Addendum / Addenda

No./N^o
2

Project Description / Description de projet M10-Electrical Vault Ventilation		
Solicitation No./ No de sollicitation 14-22068	Project No./N ^o de projet 4021	W.O. No./N ^o d'ordre de travail A1-004018-02
Project Engineer / Ingénieur de projet Josh Hale (Stantec)		Date November 12,2014
<p>Notice: This addendum shall form part of the tender documents and all conditions shall apply and be read in conjunction with the original plans and specifications.</p>		<p>Nota: Cet addenda fait partie intégrale des dossiers d'appel d'offres; toutes les conditions énoncées doivent être lues et appliquées en conjonction avec les plans et les devis originaux.</p>

5 PARTIAL ELECTRICAL SINGLE LINE
 ME02 SCALE N.T.S.

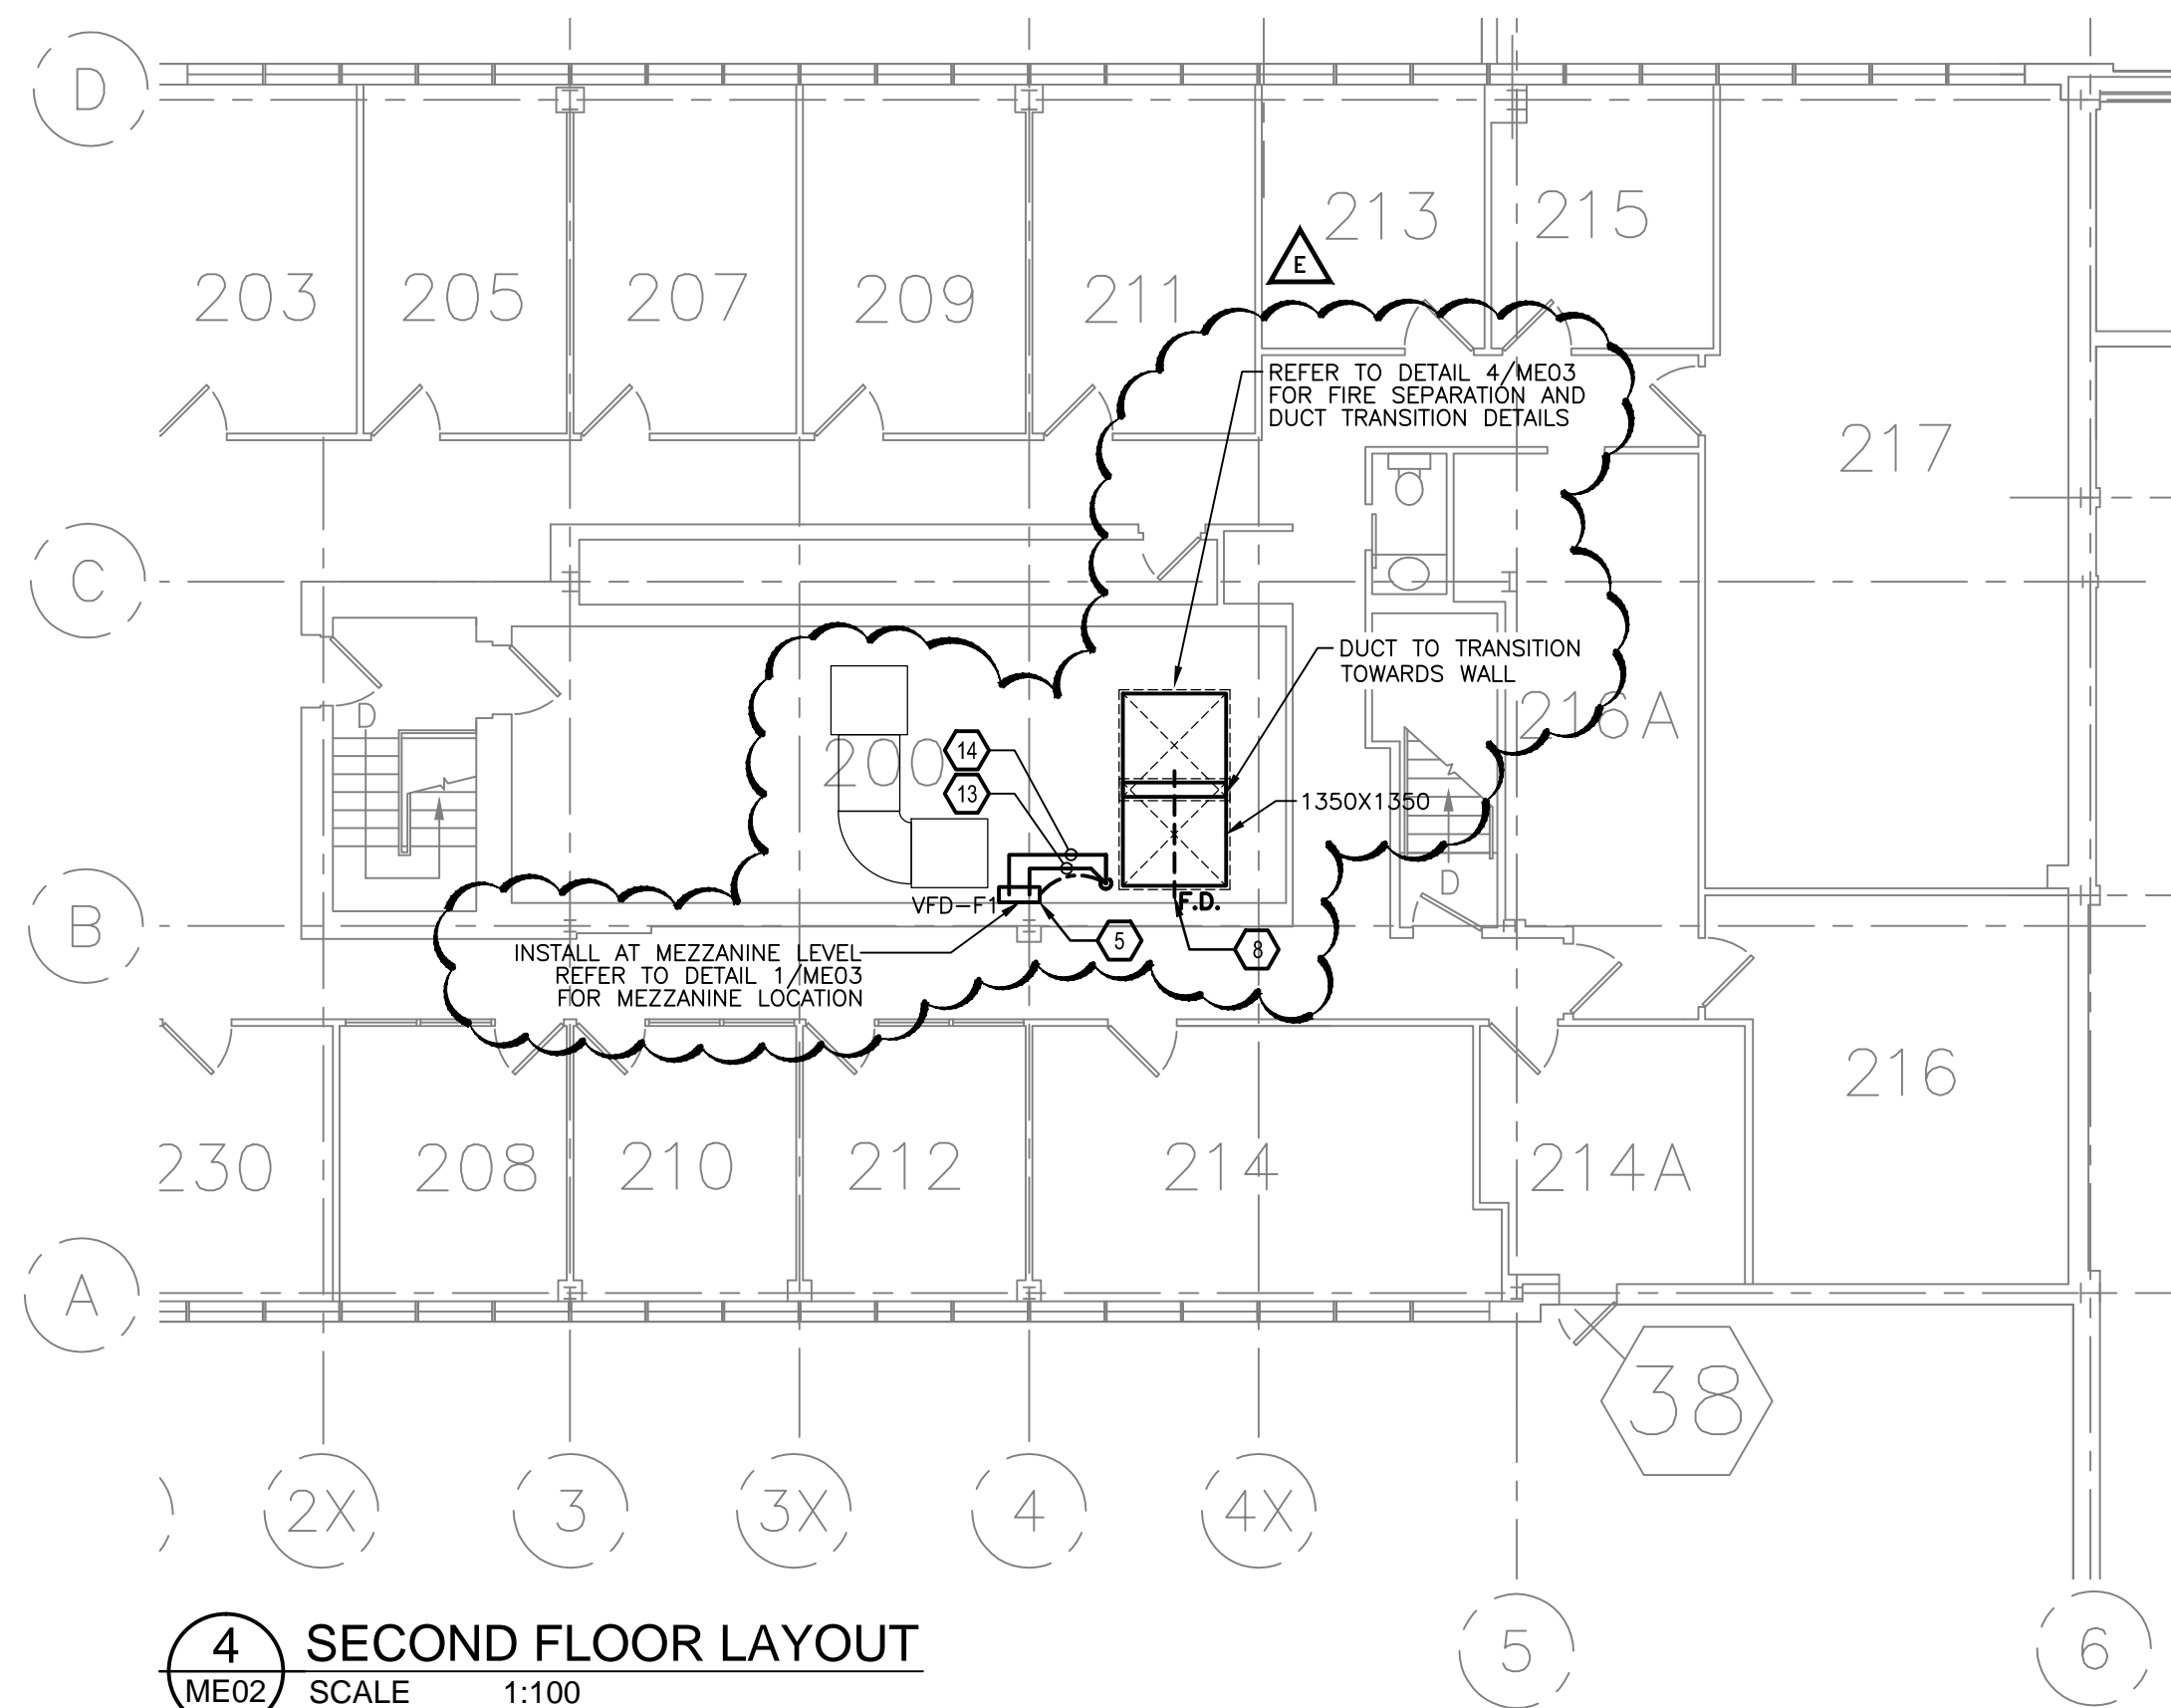
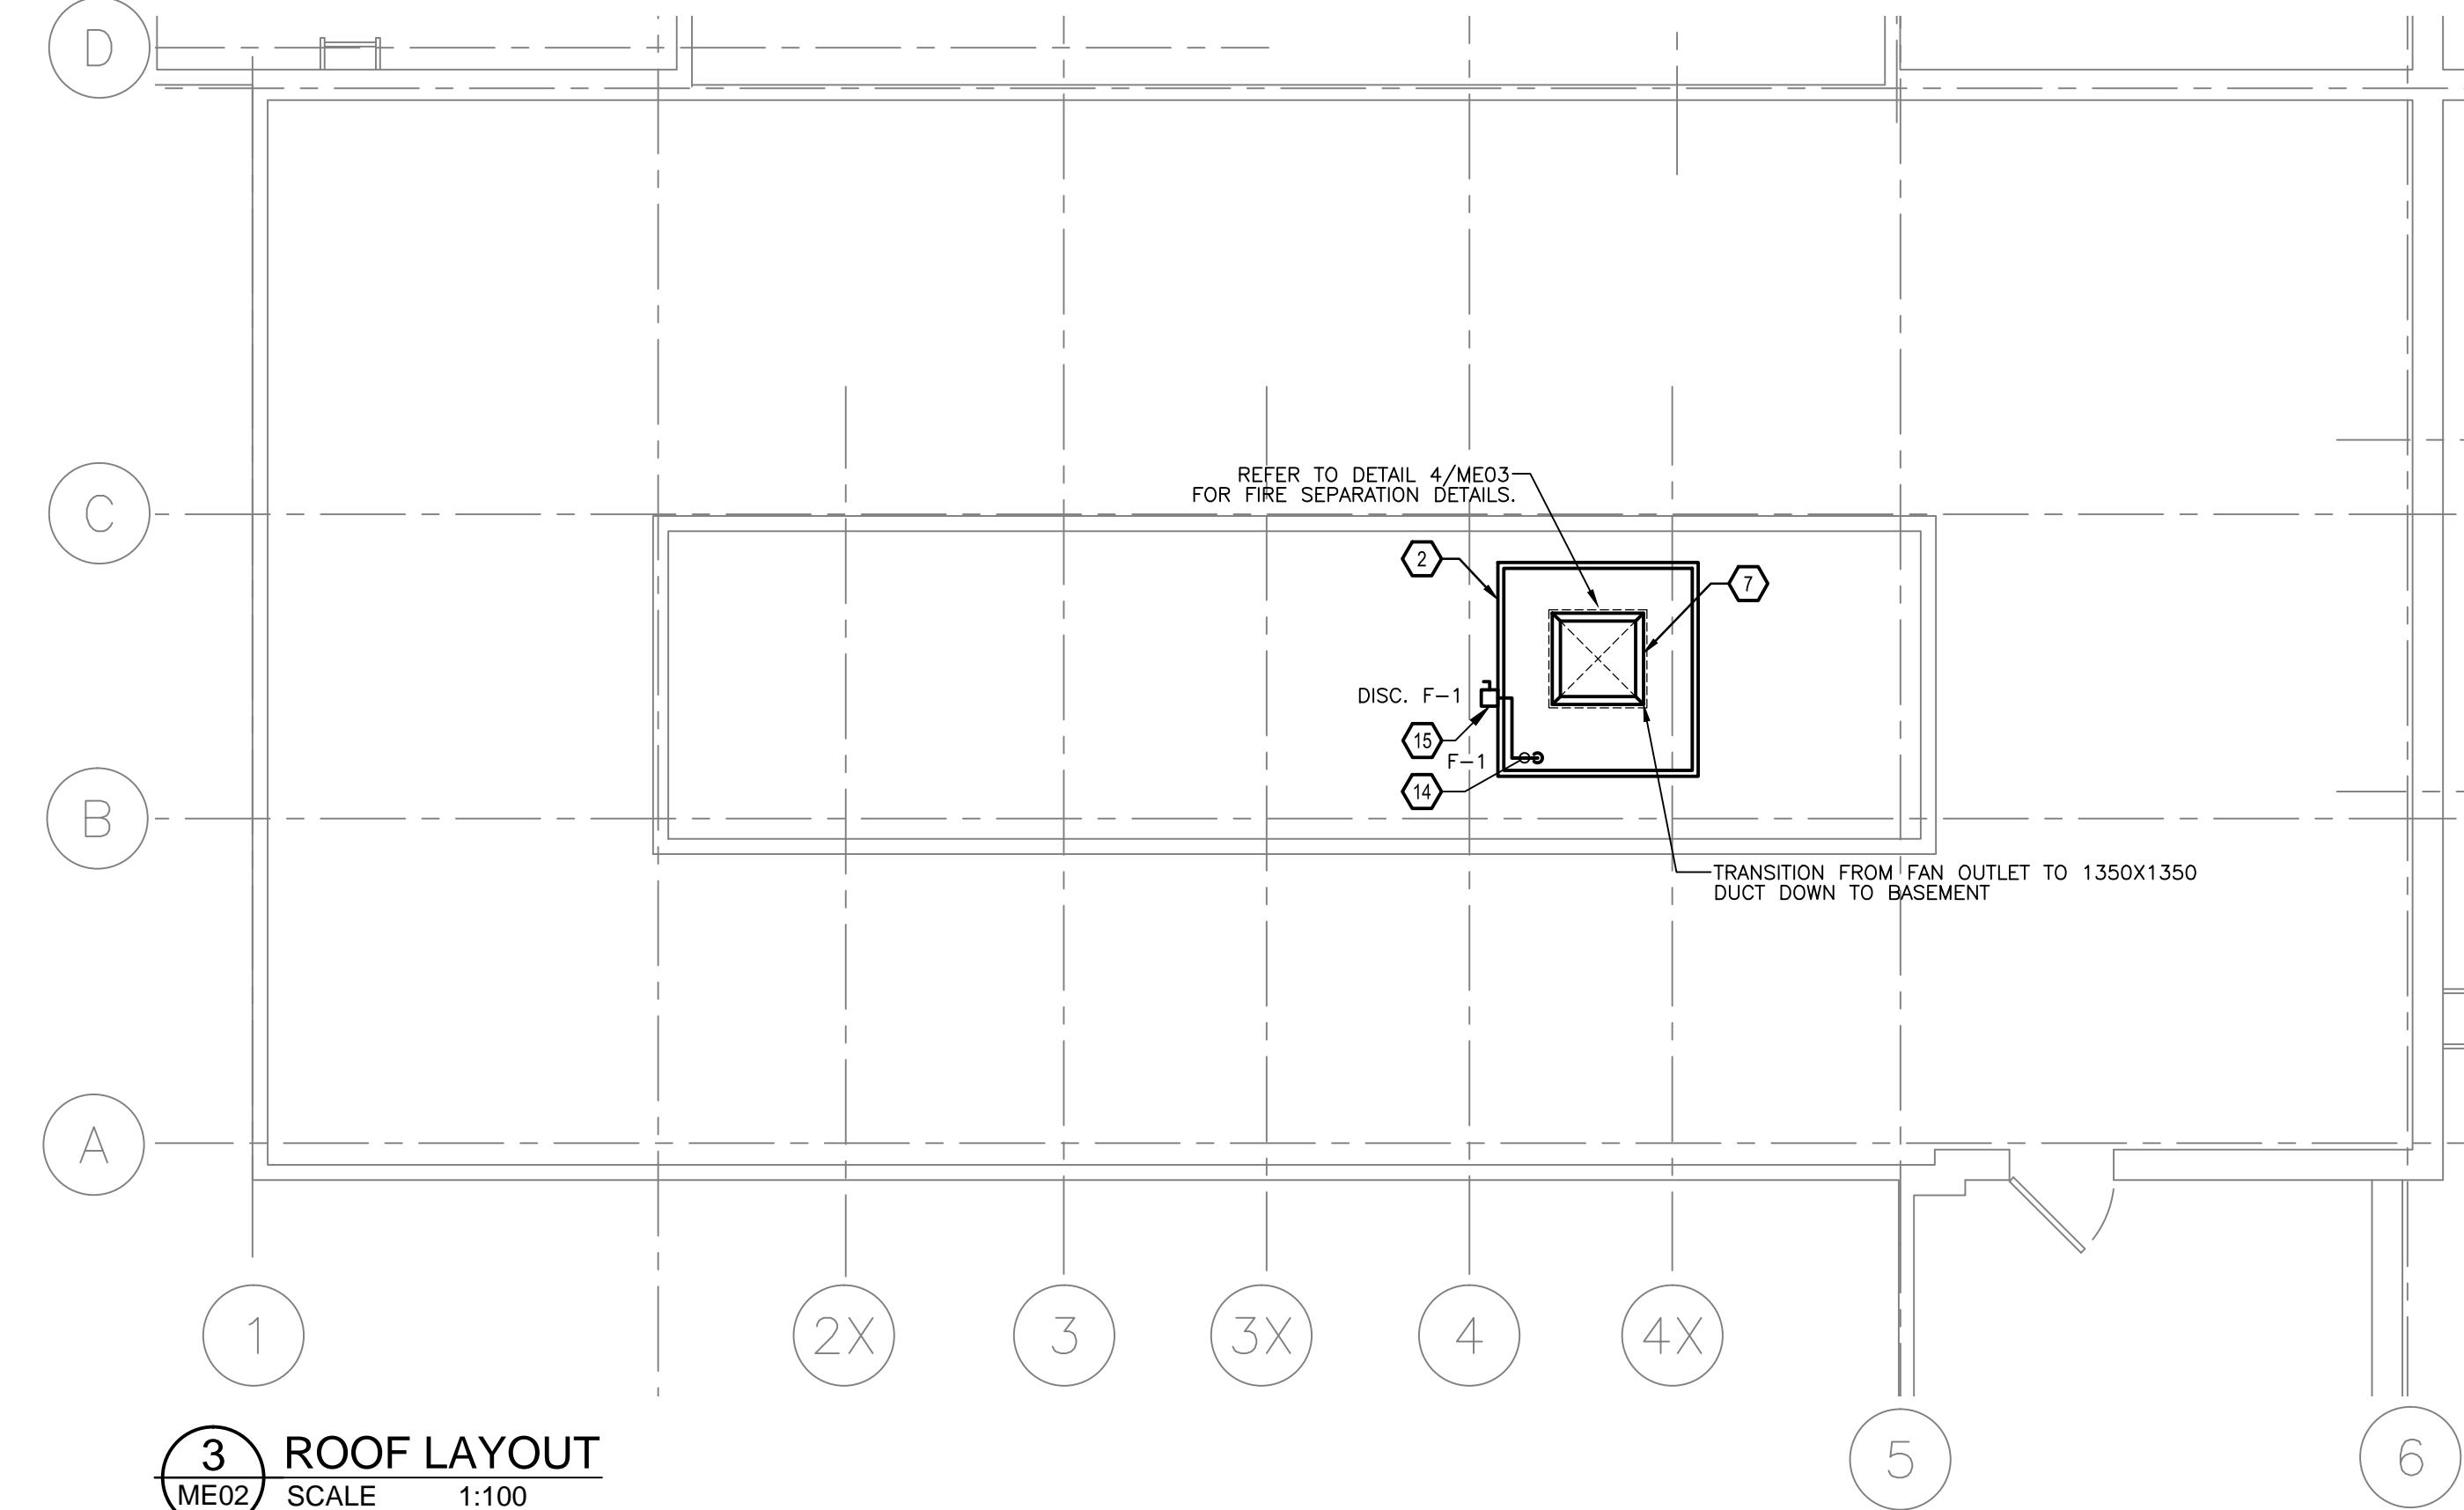
2. Drawings ME02 have been updated to show correct location of PD6
3. Drawings ME03 have been updated to show correct location of VFD, (Fan F-1) VSD to be installed inside room 200 below mezzanine.
4. Drawings ME01 have been updated to show location of piping under new backfill .

OPENING FRAMING AT ±EL. 360'-8"
 N.T.S.

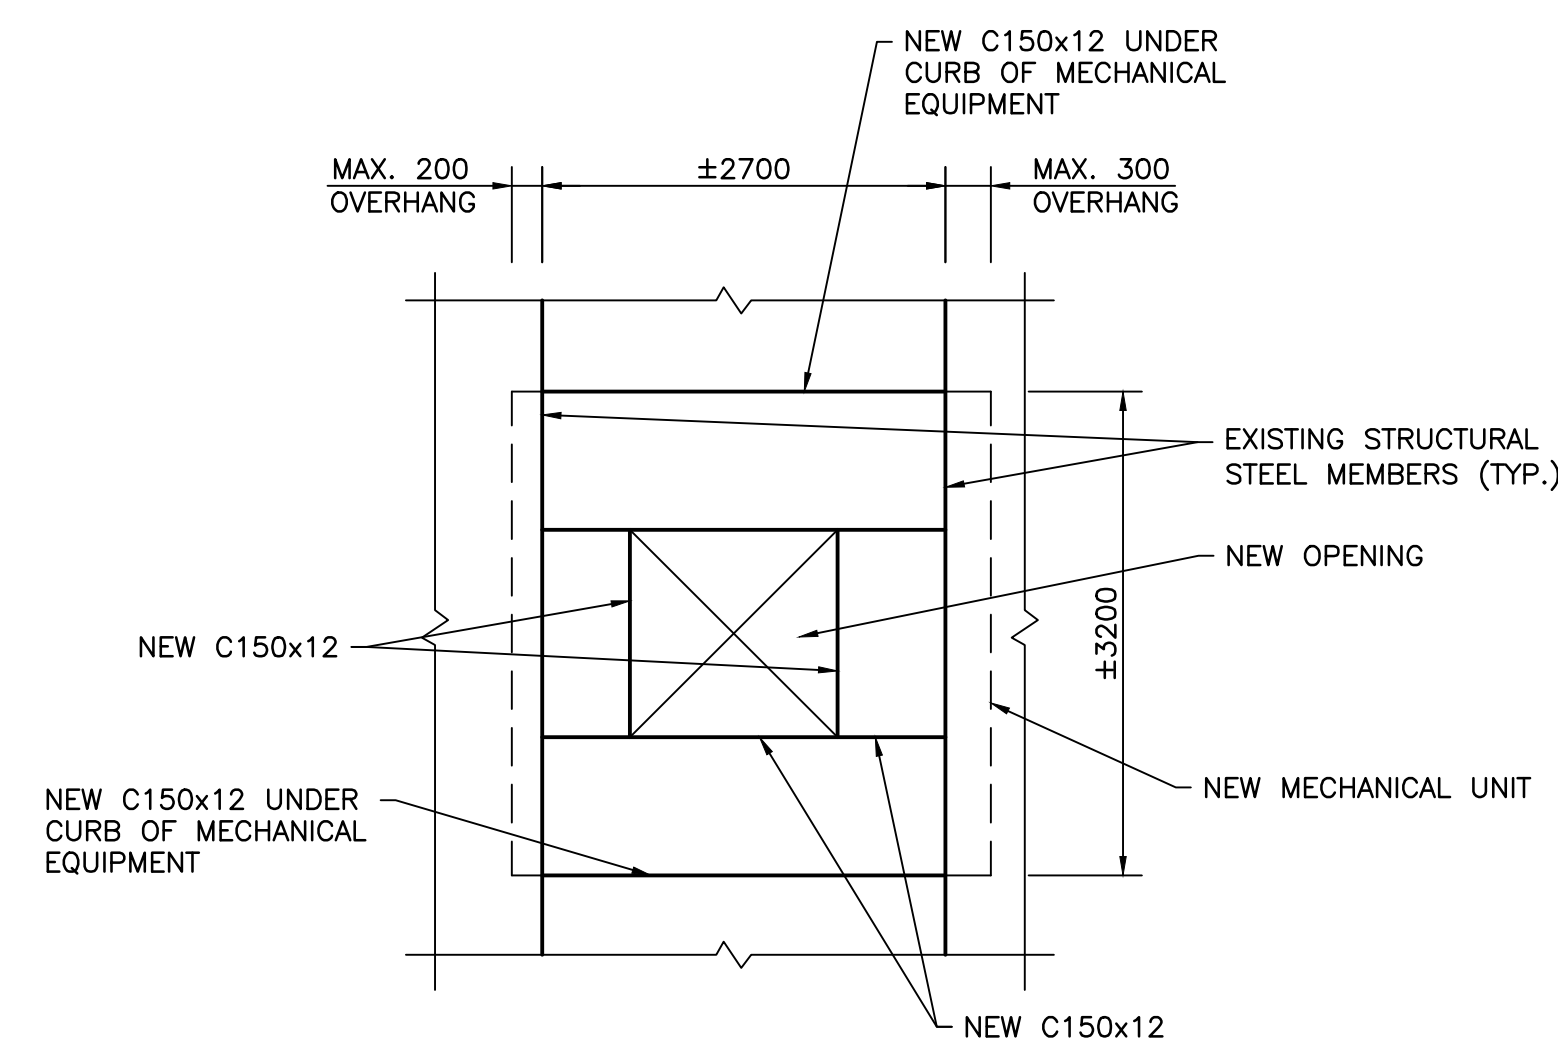
Question A: On SO2 the typical steel framing is only installed at the roof level. Please confirm.

Question D: At roof level, in order to install the new C12 structural steel under the structural slab, the 1/4" transit panels will have to be removed in order to expose the slab. What is the intention to complete the work after the structural steel and the duct work is installed, do you wish these panels to be cut and adjusted to fit the new layout between the structural steel and the duct work. I suspect that these panels contain asbestos. Please clarify.

Answer: Confirmed. Drawings have been updated.

Answer: We have added a section to our drawings showing original (1950's) design drawings for the area in question, contractors will need to assess the roof construction. New, similar in appearance and function, or existing panels should be cut and adjusted to fit new layout between structural steel and duct work.
